# LOXAHATCHEE RIVER DISTRICT

### REGULAR MEETING # 02-2025

- A. 2966 Jamaica Drive - Preliminary Assessment [Page 12](#)
- B. 31-10: Jamaica Drive Phase 2 - Subregional Line Charge [Page 16](#)
- C. Manual of Minimum Construction Standards and Technical Specifications  
– to approve revisions [Page 18](#)
- D. Water Leak Credit Policy - to review and approve [Page 242](#)
- E. Easement Abandonment - PCN # 00-42-40-33-08-015-0010 [Page 244](#)
- F. Portable Generator - to approve purchase [Page 251](#)
- G. Fixed Asset Disposal - to approve disposal [Page 256](#)
- H. Change Order to Current Contract - to approve modifications [Page 257](#)

Staff have implemented a Standards Review Committee to manage change control of the construction standards and technical specifications. This Committee meets quarterly and follows strict procedures governing change requests, investigation, recommendation/authorization and implementation of changes to the construction standards and technical specifications.

LP-1

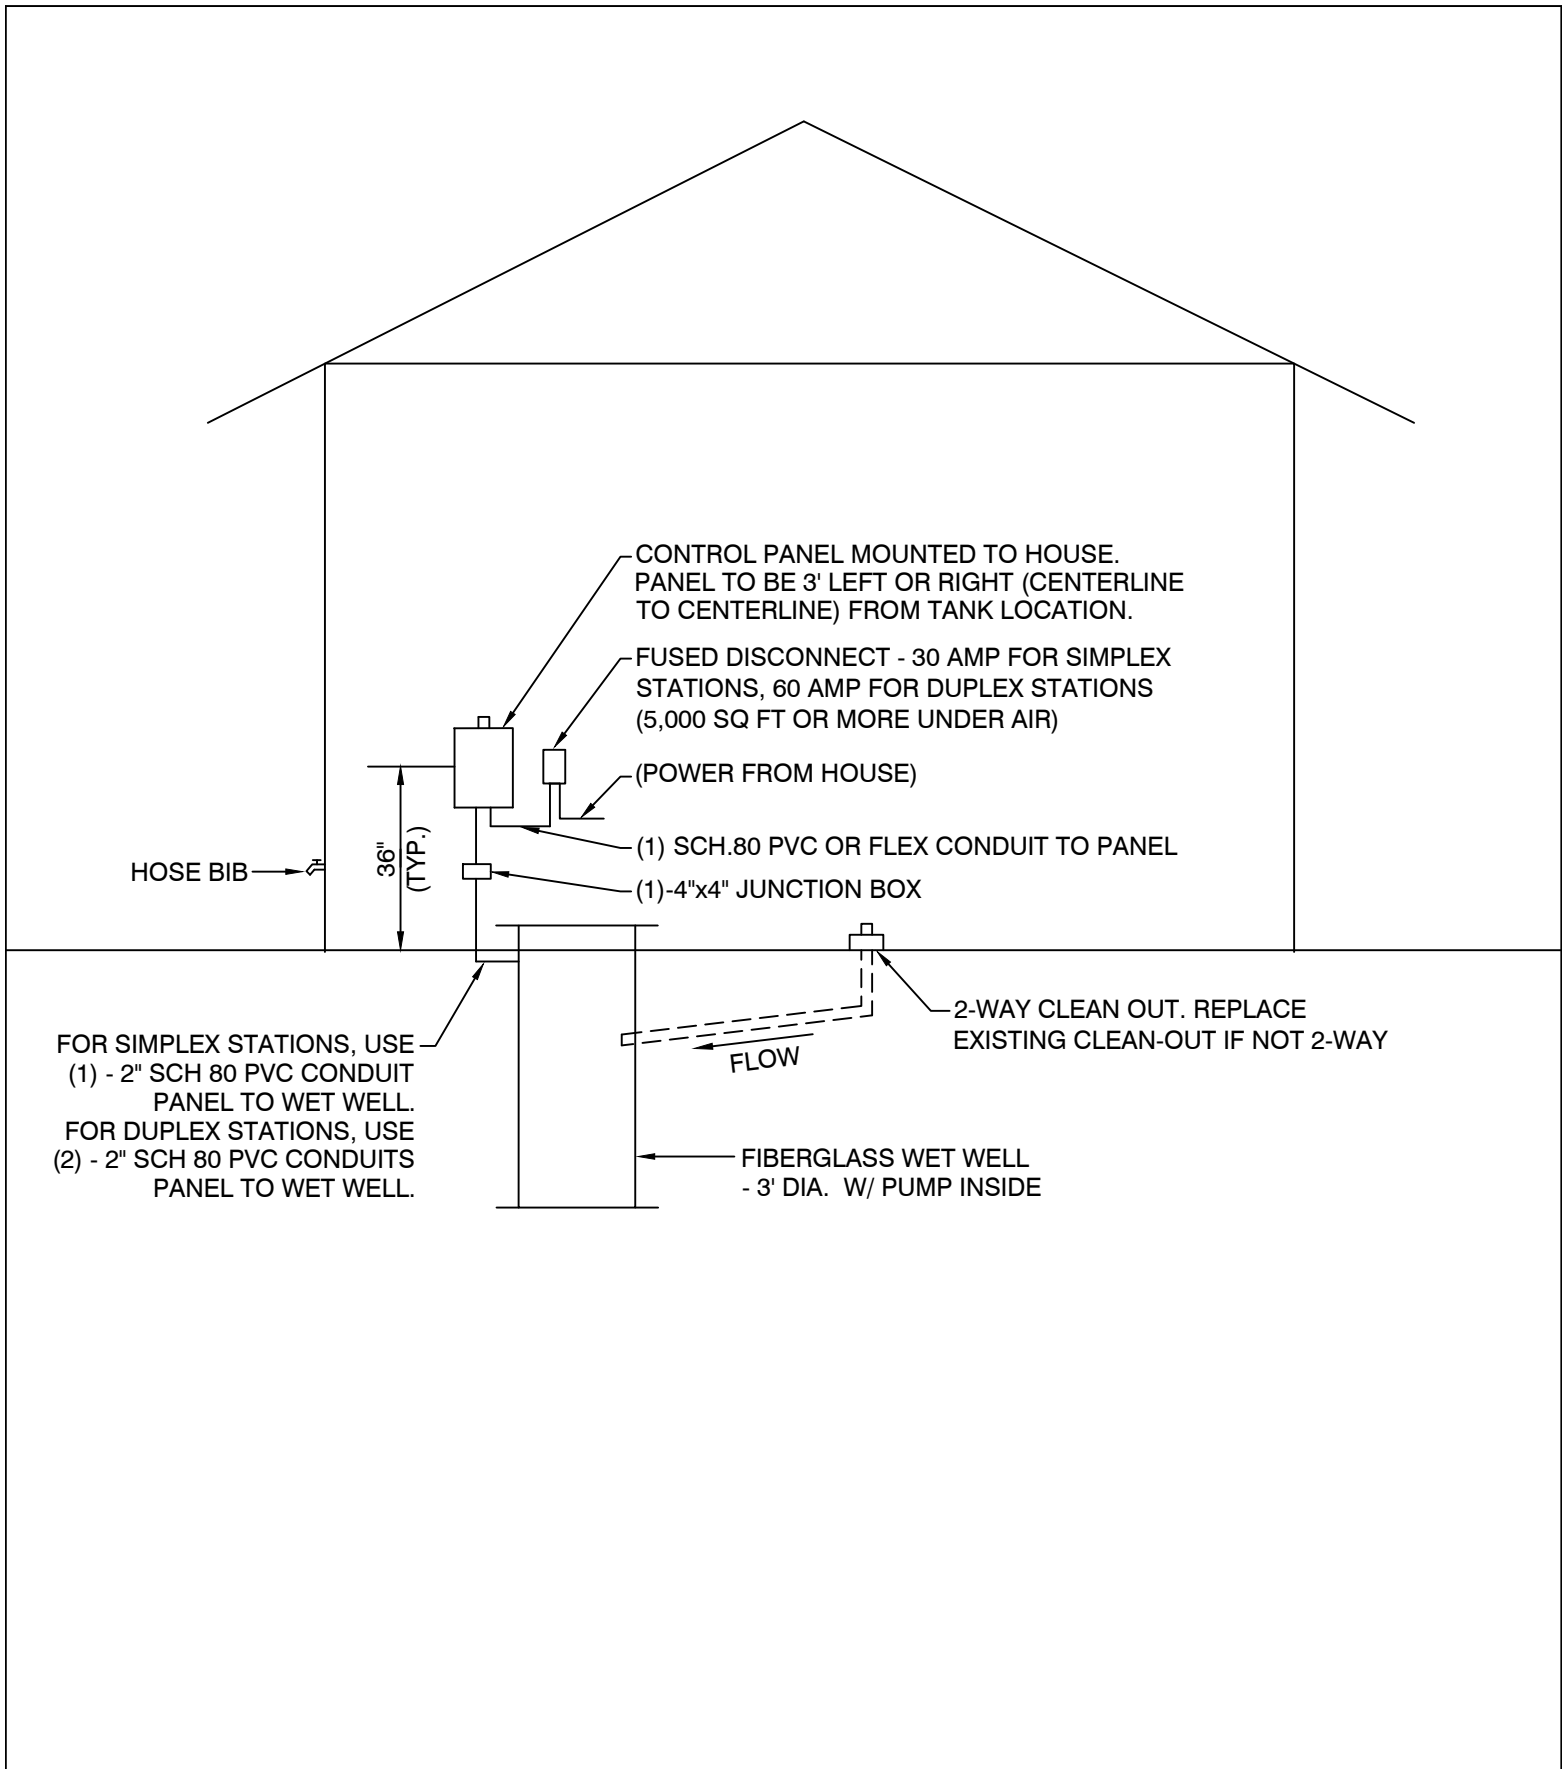
21. Standard Details LP-1 through LP-3
  - a. General clean-up of the details and added references to other District Standards
22. Standard Detail LP-5 – Clarify notes on detail for simplex vs. duplex requirements.

**LP-12**

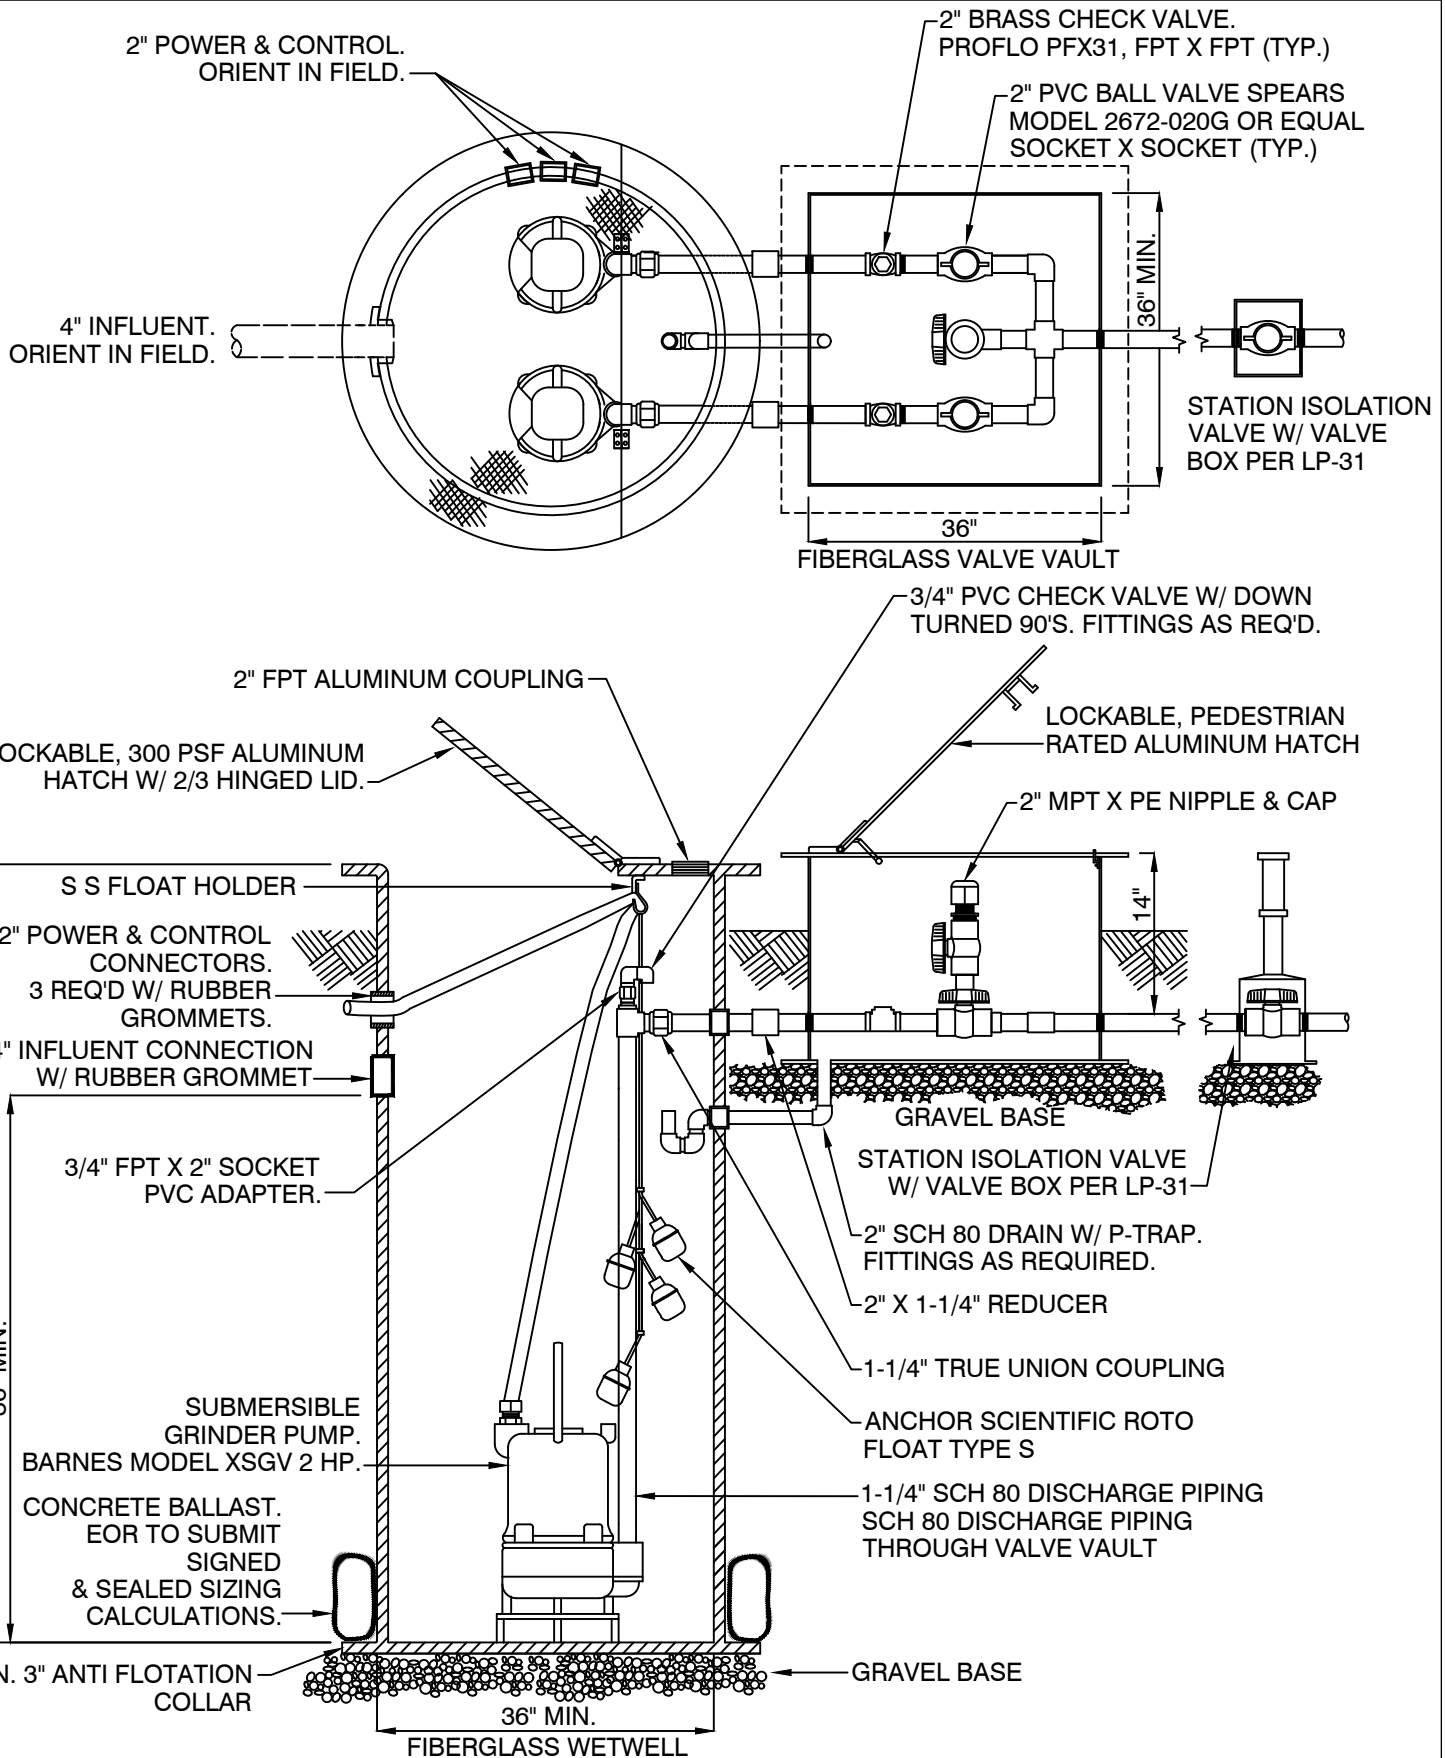
25. Standard Detail LP-12, LP-12 ALT – Add valve box clarification for station isolation valve.
26. Standard Detail LP-13 – Update notes to clarify seal-offs above junction box and terminal strip inside junction box to be consistent with Standard Detail SD-33.

LP-16

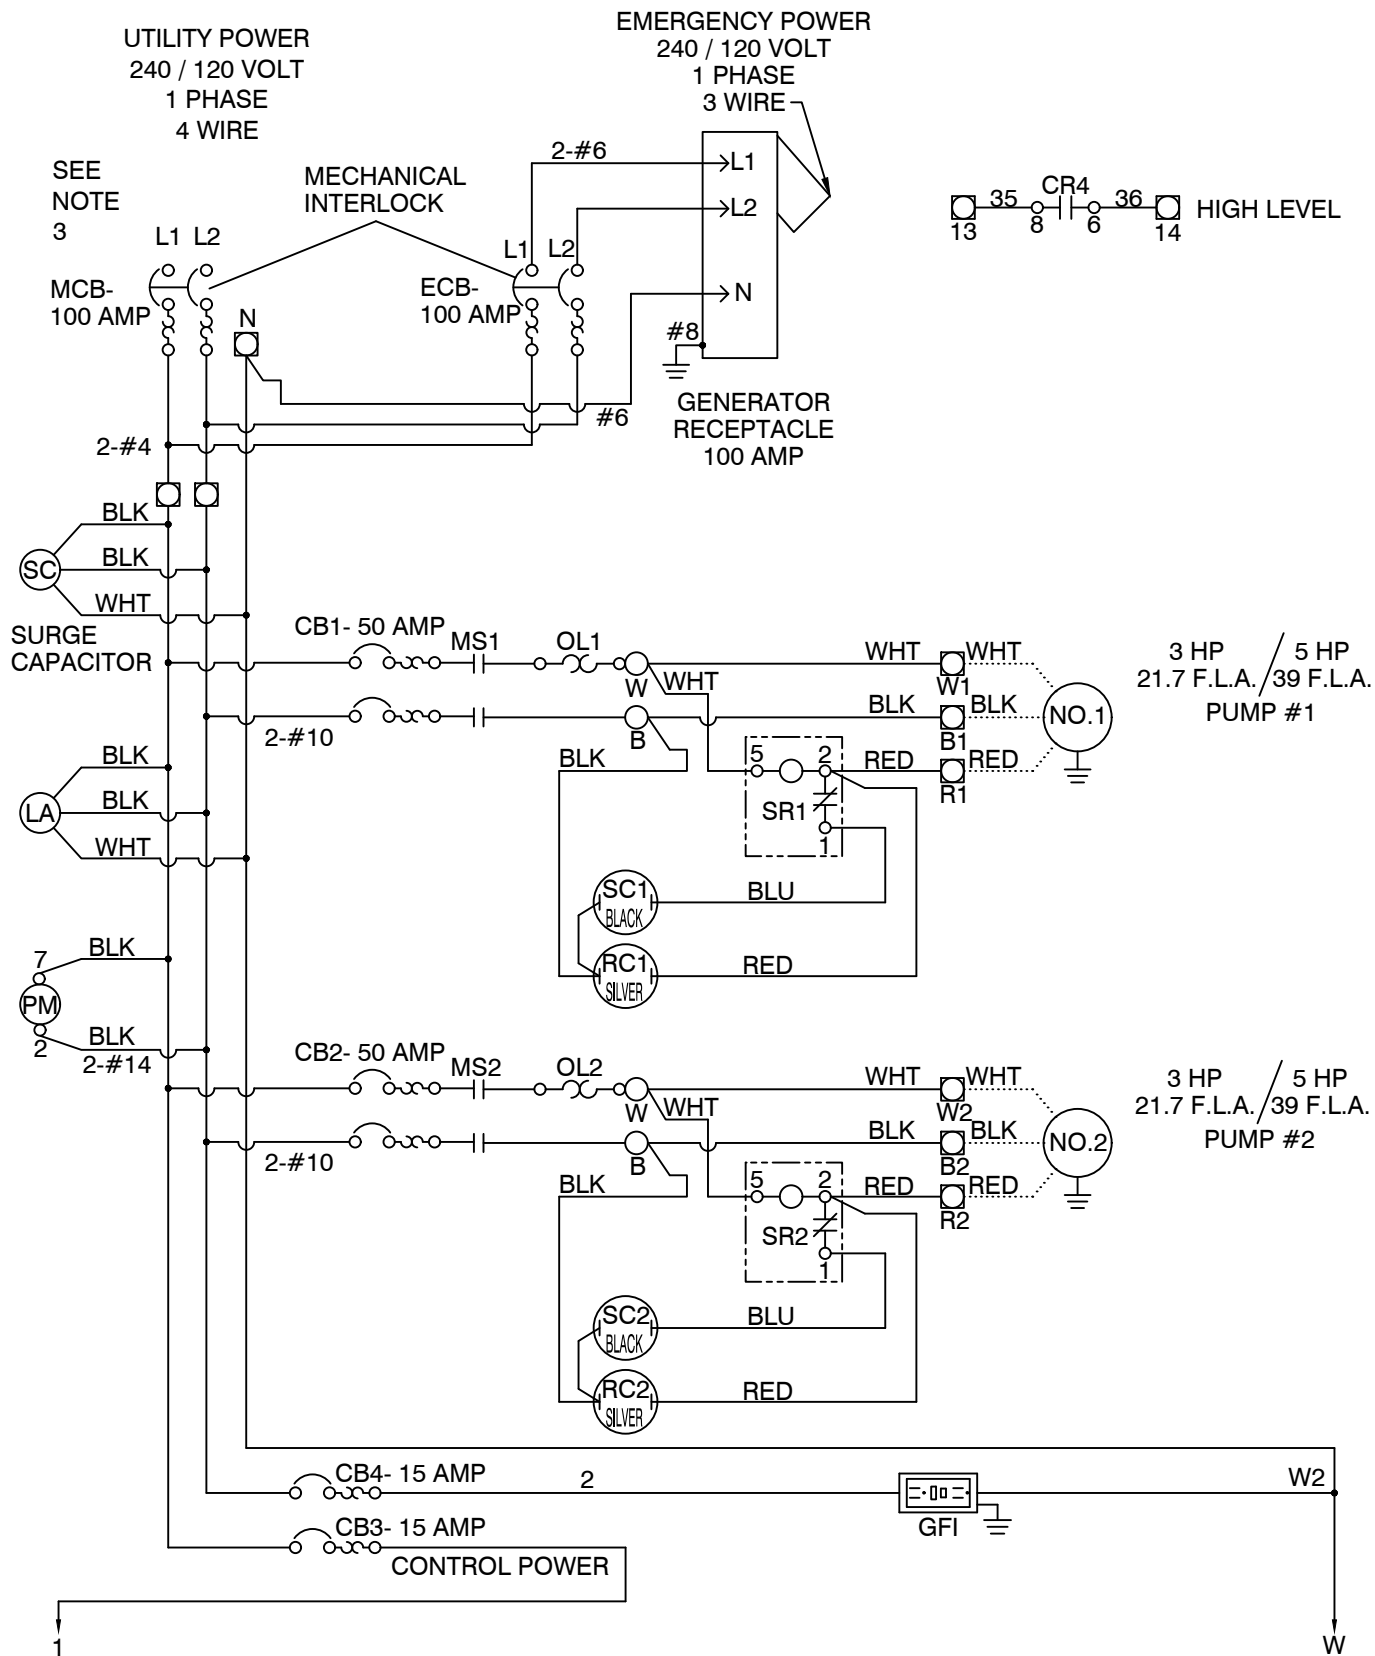
27. Standard Detail LP-16 – Clarify screw cap for generator receptacle for commercial duplex station.
28. Standard Detail SD-5 – Updated Note 8 to clarify larger access openings required for interceptors with chimney's greater than 12".
